7806 Santa Elena St Glenbrook Valley

#### CERTIFICATE OF APPROPRIATENESS

**Proposal:** Alteration - Installation and removal of front door and side lites without a COA due to rot and damage.

July 29, 2021 HPO File No. 2021\_0157 7806 Santa Elena St Glenbrook Valley

# **Current Photograph**

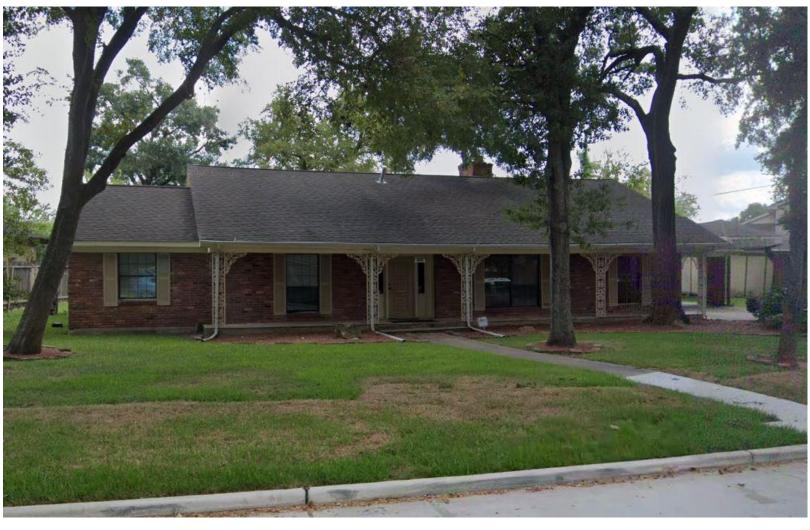
- Removed original single-door with double metal doors.
- Removed two original side lites.

(3)	The proposed activity must recognize the building, structure, object or site as a product of its own time and avoid alterations that seek to create an earlier or later appearance; Replacement Door does not match the materials or character of traditional ranch style home. Removal of original side lites does not match the architectural features.

Recommendation: Denial - does not satisfy criteria; Issuance of a COR to replace door for a more appropriate

style and to reinstall two side lites.
